Customer	: CU-DAR001 Dart Helicopters Services	Drawing Name	: HELI UTILITY BASKET LH/RH 350/355
Job Number	: 36679		
Estimate Number	: 10208		
P.O. Number	:	Part Number	: D350607043
This Issue	: 1/9/2008 S.O. No. :	Drawing Number	: D350-607 REV F P7-9
Prsht Rev.	: NC	Project Number	: N/A
First Issue	: / / Type : LARGE FAB ASSY	Drawing Revision	: F
Previous Run	: 36678	Material	:
Written By	:	Due Date	: 1/31/2008 Qty: 1 Um: Each
Checked & Approved By	: <u>08.01.09</u>		
Comment	: Est Rev:E as Per DSI9318 06-01-24 JLM Est Rev:F ECN1068 07-12-21 DD

DESIGN <i>CP</i>	DRAWN BY <i>CP</i>	DART AEROSPACE LTD HAWKESBURY, ONTARIO, CANADA	
CHECKED <i>[Signature]</i>	APPROVED <i>[Signature]</i>	DRAWING NO. DSI 9318	REV. A SHEET 1 OF 1
DATE 06.01.06		TITLE WASHER ADDITION	SCALE NTS
A	06.01.06	NEW ISSUE

# DART SERVICE INSTRUCTION

TO AMEND INSTALLATION INSTRUCTIONS D350-607 REV. F

**Figure 5- Basket Replacement Parts**  
(D350-607-043 Heli-Utility-Basket™)

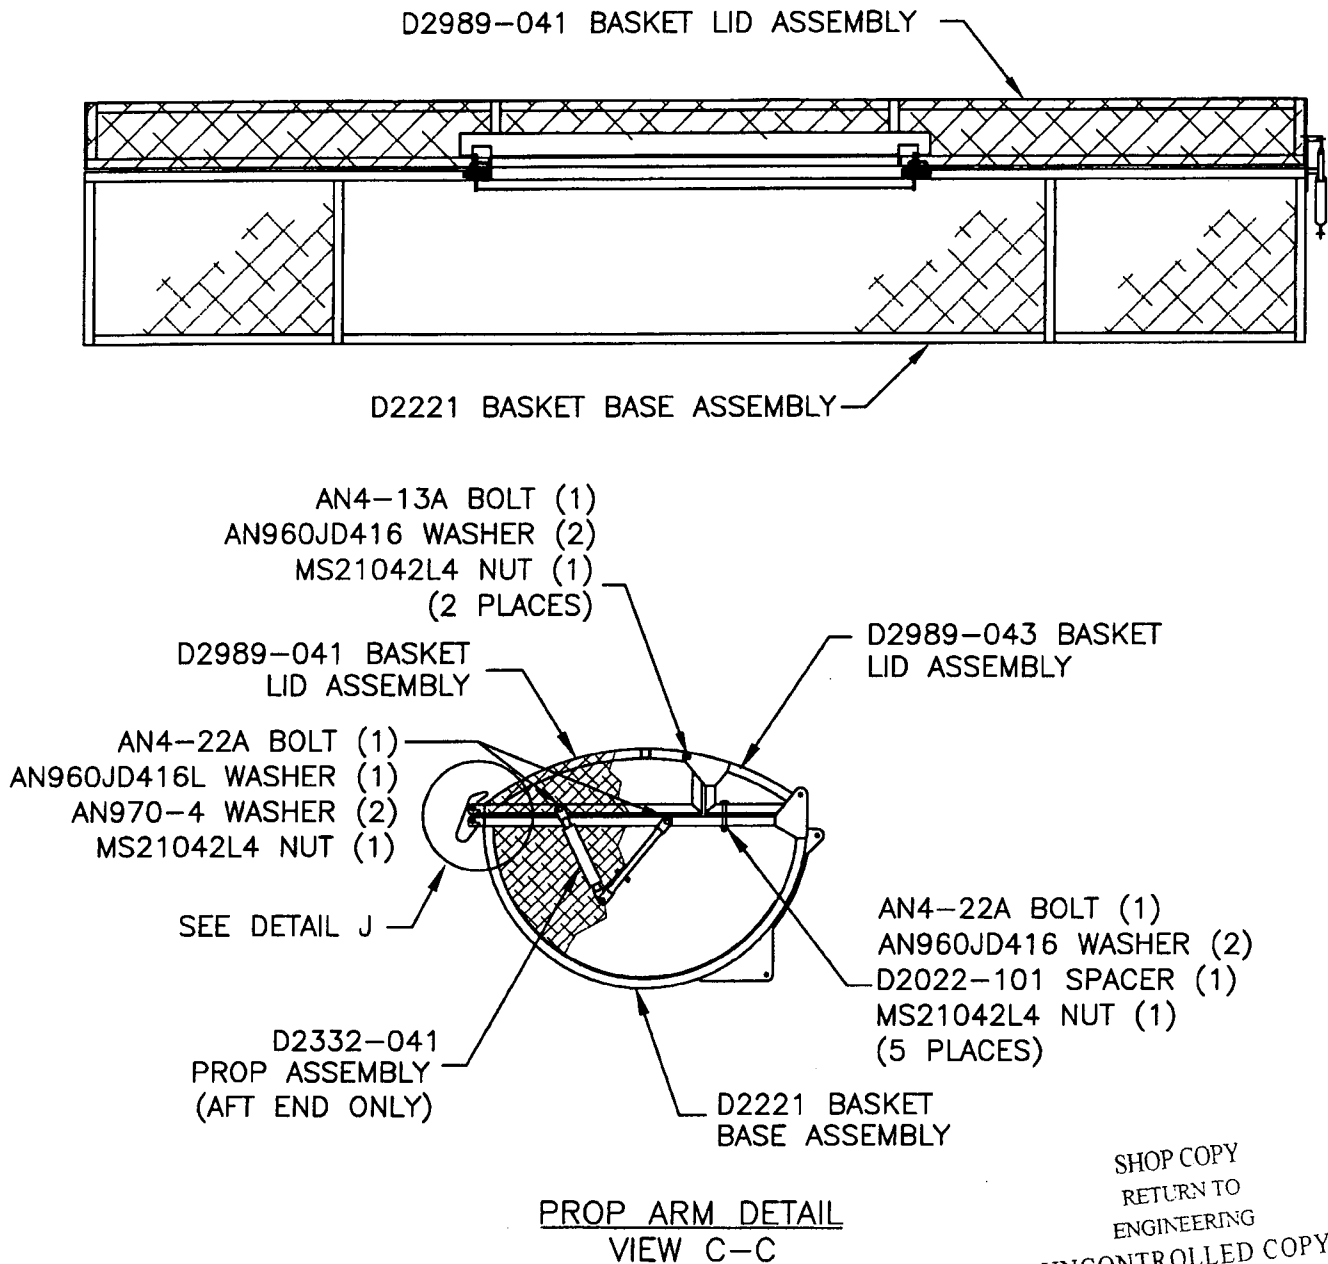
The corrected bolt stackup from Figure 5 of installation instructions D350-607 Rev. F is given below:

AN4-13A BOLT (1)  
AN960JD416 WASHER (1)  
HINGE PLATE (REF)  
**NAS1515H4 WASHER (1)**  
BASKET FRAME (REF)  
AN960JD416 WASHER (1)  
MS21042L4 NUT (1)  
(2 PLACES)

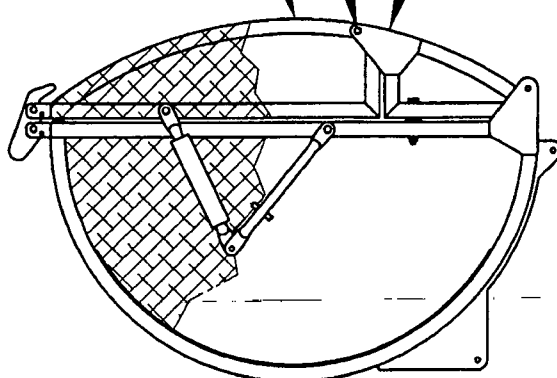
To reduce the possibility of damaging the finish, a **NAS1515H4** washer (2 places) has been added between the hinge plate and basket frame on the **D350-607-043/-047 Heli-Utility-Basket**.
